The amendments revise the provisions of Section 6.0 of the Technical Specifications related to reorganization of the Chemistry and Health Physics groups.

Amendment No. 22
License No. DPR-32

SAFETY EVALUATION BY THE OFFICE OF NUCLEAR REACTOR REGULATION
SUPPORTING AMENDMENTS NO. 22 TO LICENSES NOS. DPR-32 AND DPR-37

SURRY POWER STATION UNITS 1 & 2

**VIRGINIA ELECTRIC AND POWER COMPANY
SURRY POWER STATION
ORGANIZATION CHART**

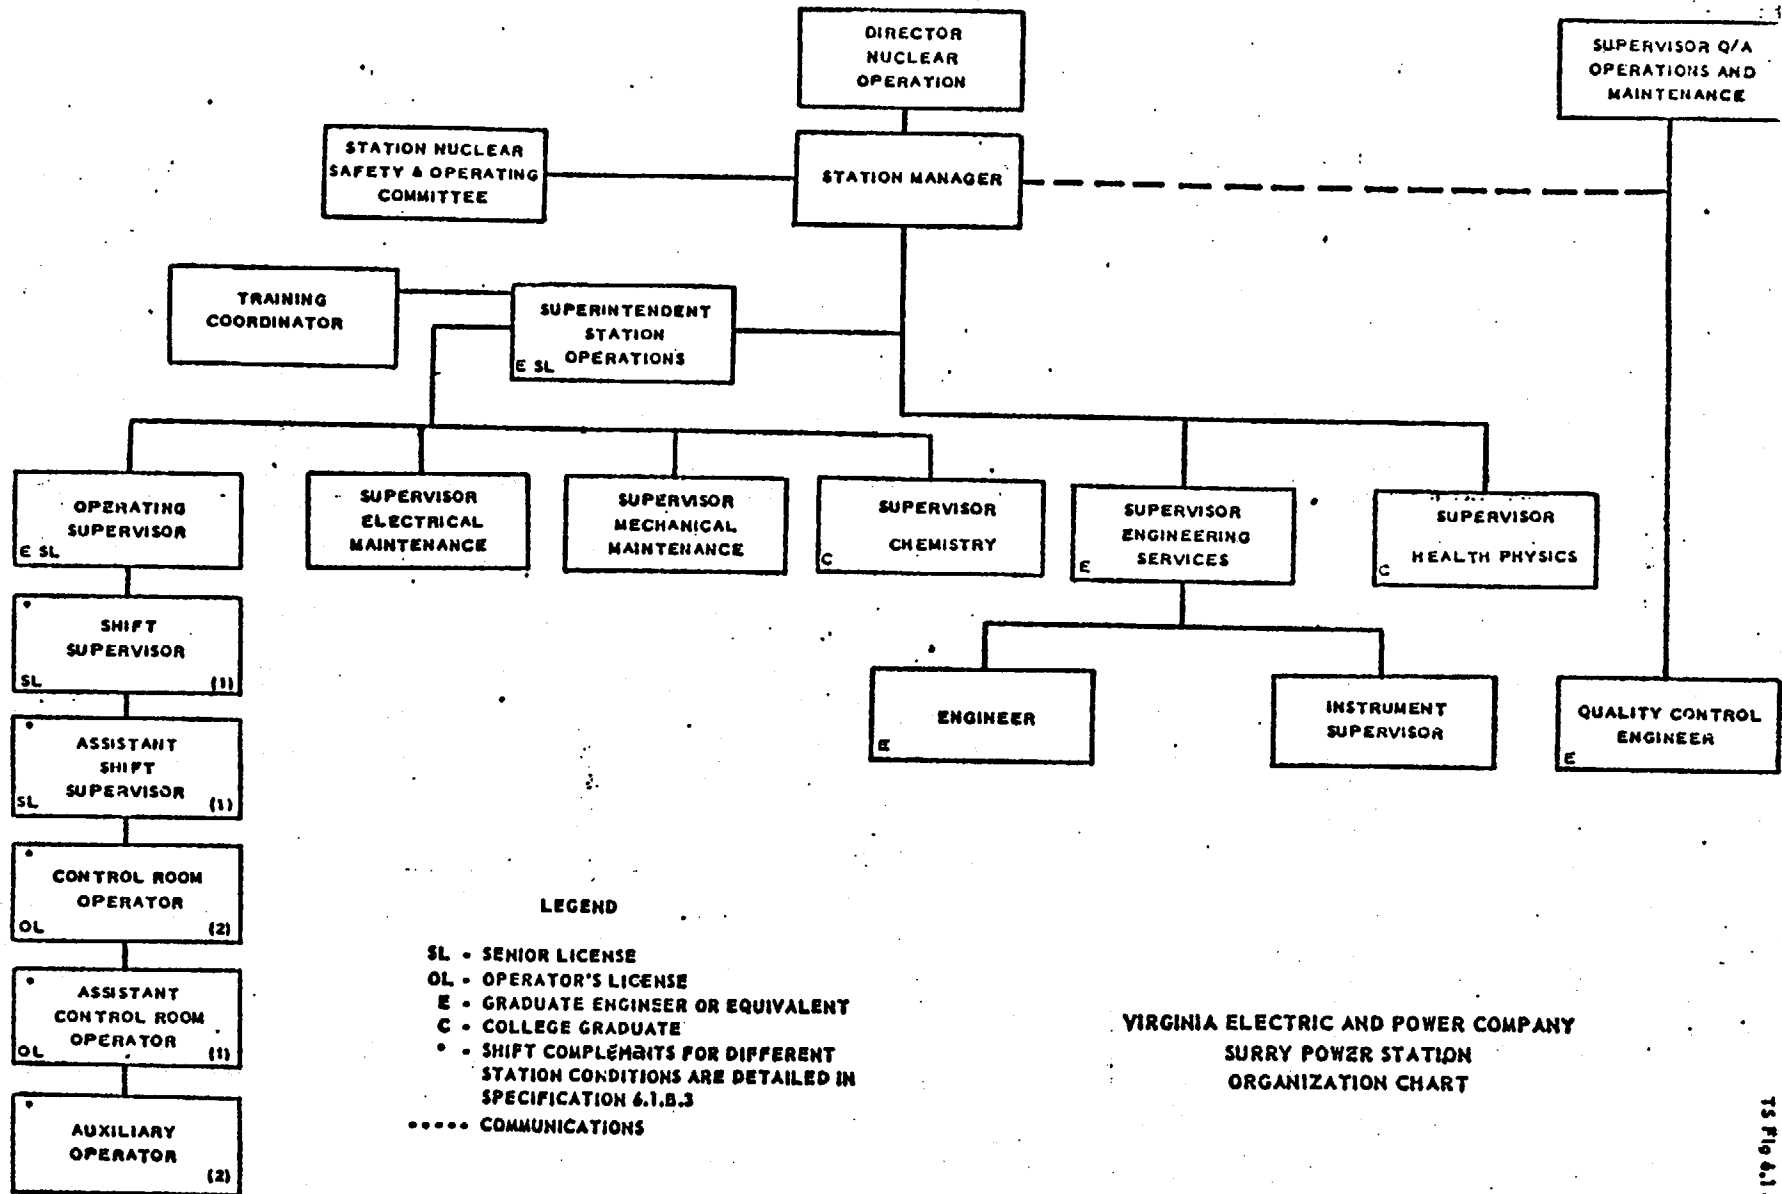
Replace pages TS6.1-1, TS6.1-3, TS Fig. 6.1-3, TS 6.4-2, TS6.4-7a and TS 6.4-7b with the attached pages bearing the same numbers. Changes on these pages are shown by marginal lines.

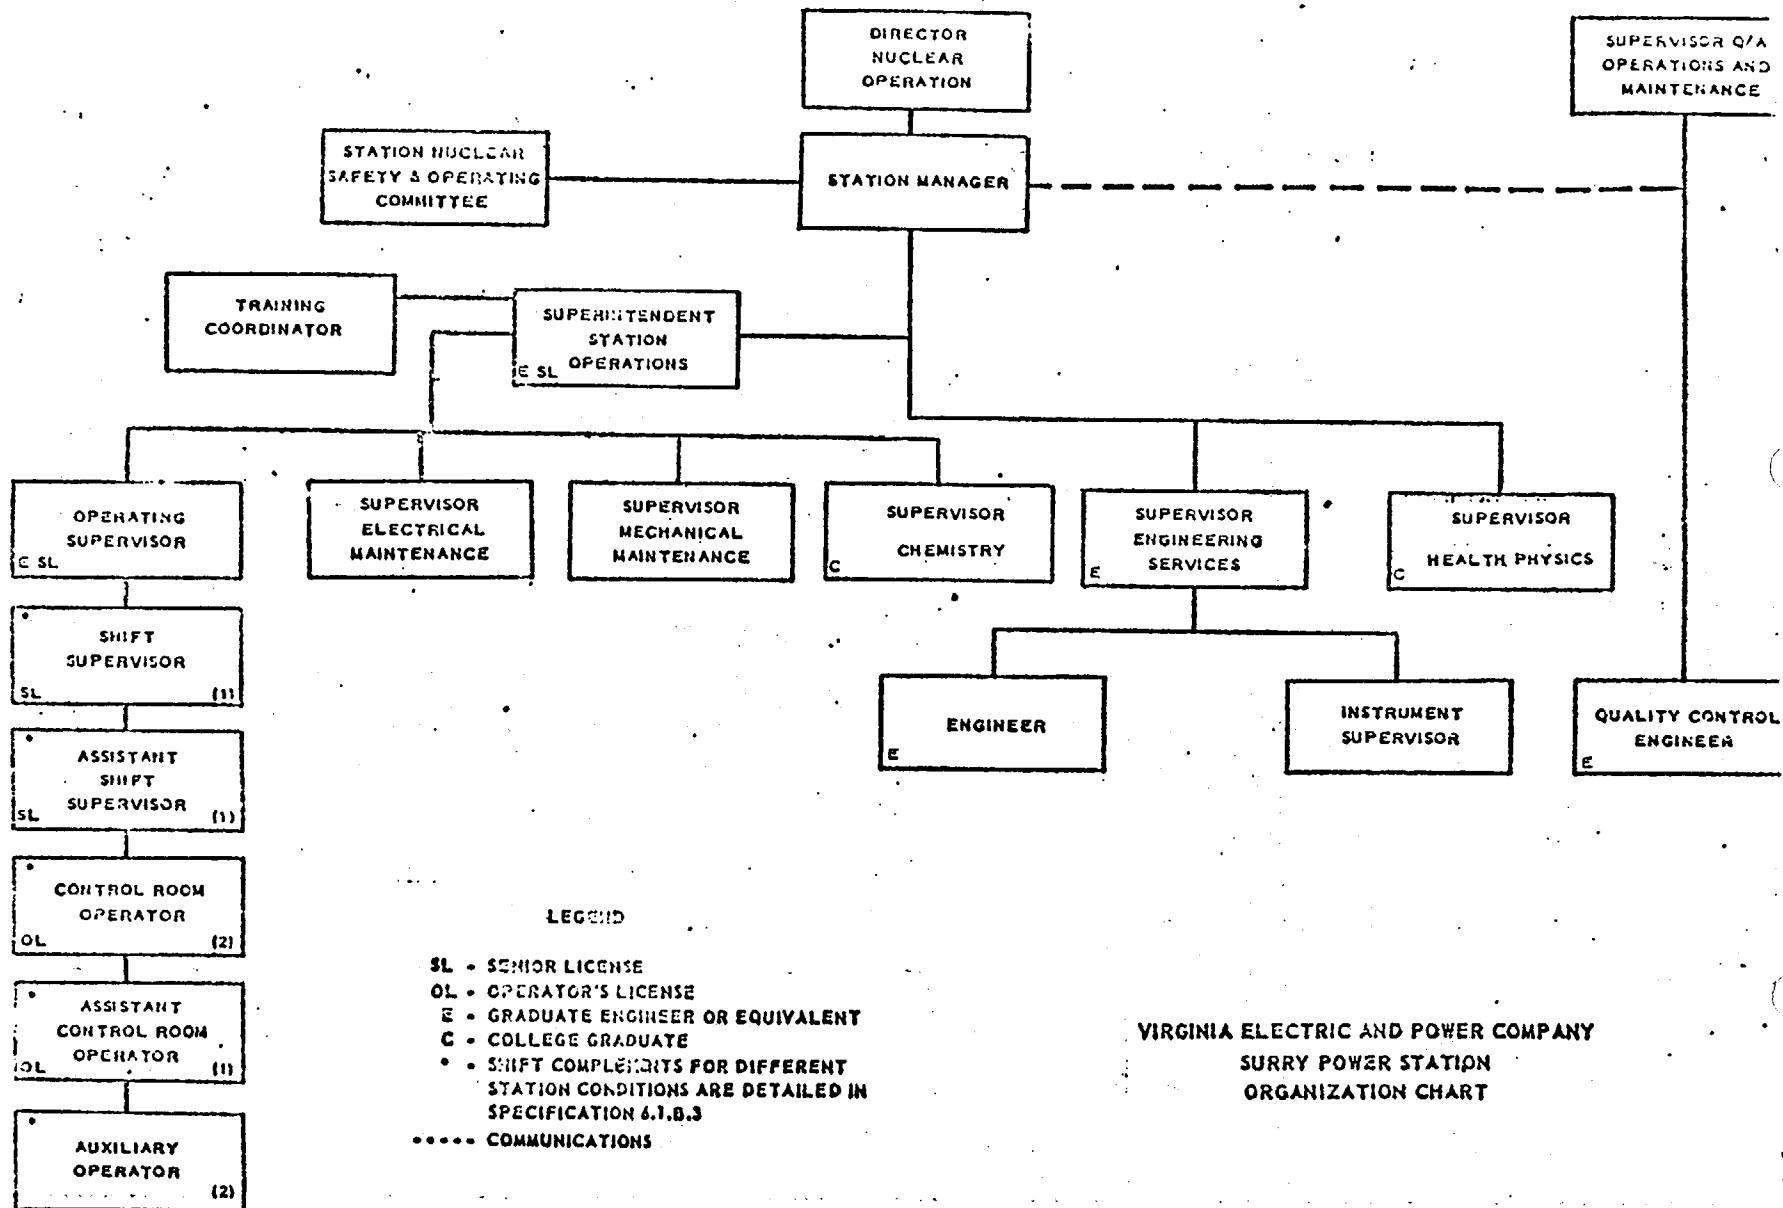
Replace pages TS6.1-1, TS6.1-3, TS Fig. 6.1-3, TS6.4-2, TS6.4-7a and TS6.4-7b with the attached pages bearing the same numbers. Changes on these pages are shown by marginal lines.
